Amendment No. 1

INTERCONNECTION AGREEMENT

Santa Rita Wind Energy LLC

January 3, 2017

Exhibit "C1"

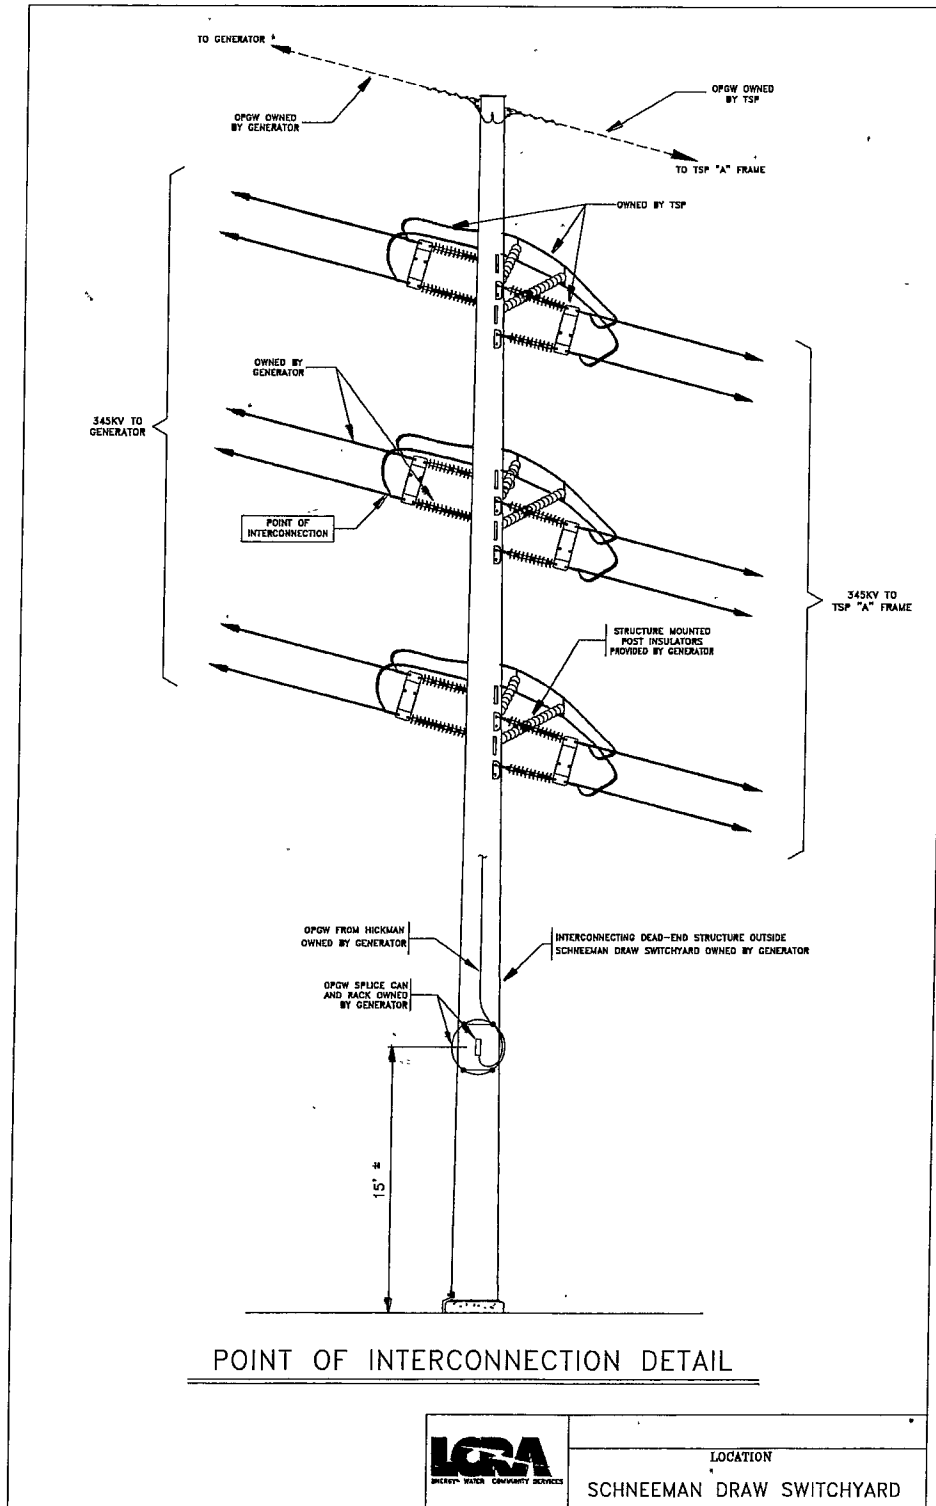
WHEREAS, Generator notified TSP of a change in the proposed conductor type and length for the Generator owned 345-kV line from the Generator's step-up substation to the Point of Interconnection outside the TSP Substation;

WHEREAS, the TSP desires to move to the TSP Substation, certain EPS metering equipment that had previously been planned to be installed at the Generator's interconnecting substation as part of the TIF.

1. Exhibits "B", "C", "C1", "C2a", "C2b", "C3" and "E" are deleted in their entirety and the Exhibits "B", "C", "C1", "C2", "C3" and "E" attached to this First Amendment are hereby added to the Agreement in lieu thereof.
2. Exhibits "B", "C", "C1", "C2", "C3" and "E" attached to this First Amendment will become effective upon execution of this First Amendment by the Parties.
